# NATIONAL RADIO COMPANY, INC.

## CUSTOMER SERVICE BULLETIN

Subject: NCX-3 Suggestions &  
Operational Hints

ADDENDA SHEET

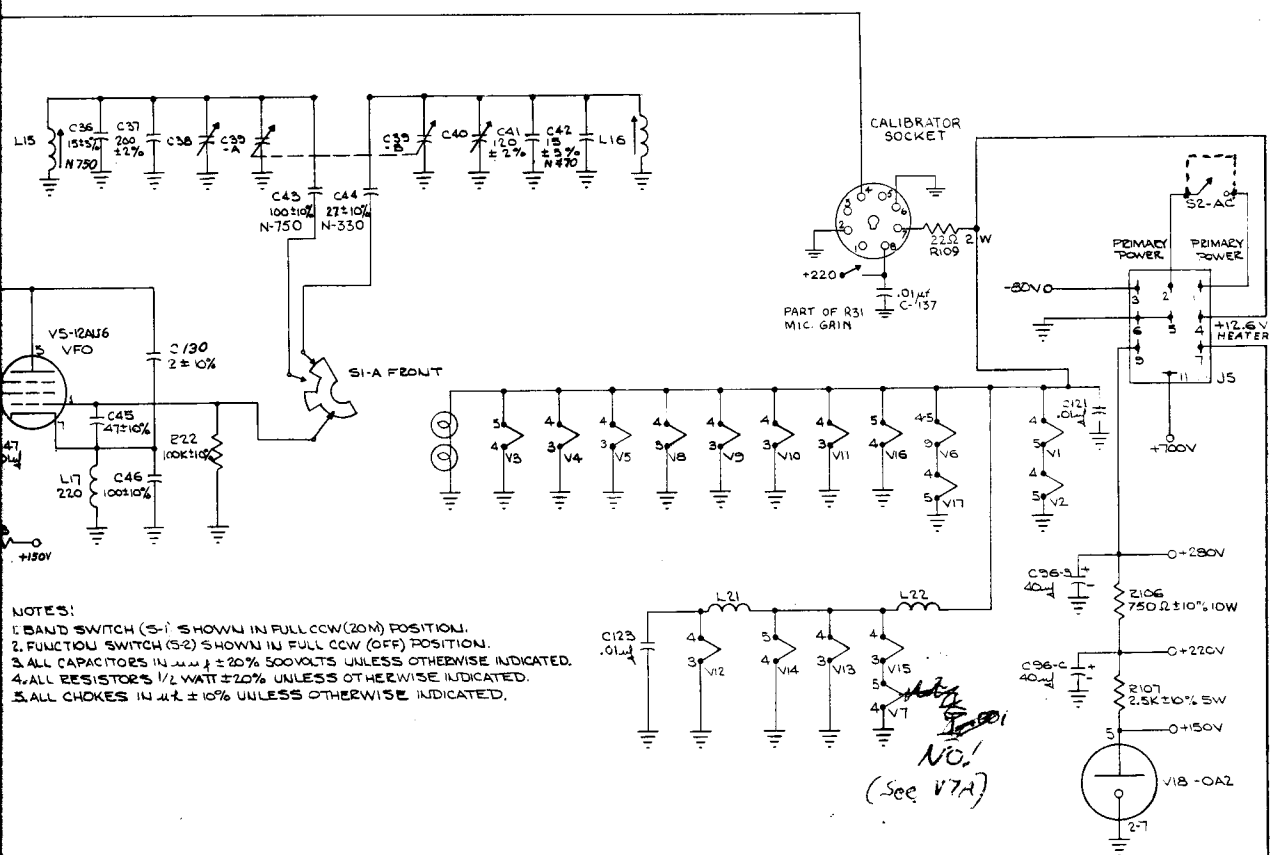
\* R44 removed per letter from National

MODEL NCX-A

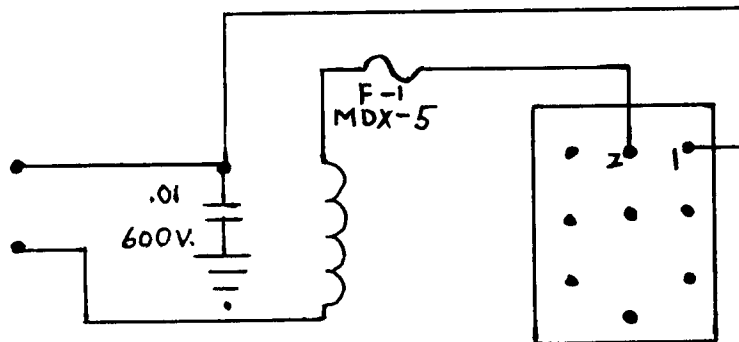
1. Resistor R7 has been changed from  $1000 \Omega \pm 10\%$  to  $1800 \Omega \pm 10\%$ .
2. A 0.01 uf 600 volt capacitor from one side of the AC line to chassis is not indicated on the schematic.
3. A revised primary power schematic is shown below:

IMPROVED TRACKING OF 80 METER  
GRID DRIVE

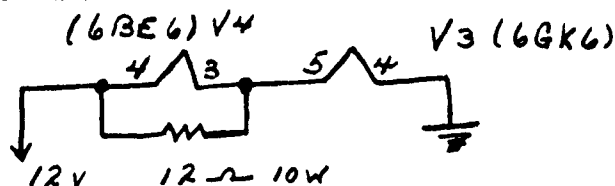
Change C-18 from 240pf to 220pf 5%. Repeak 80 meter driver coil.
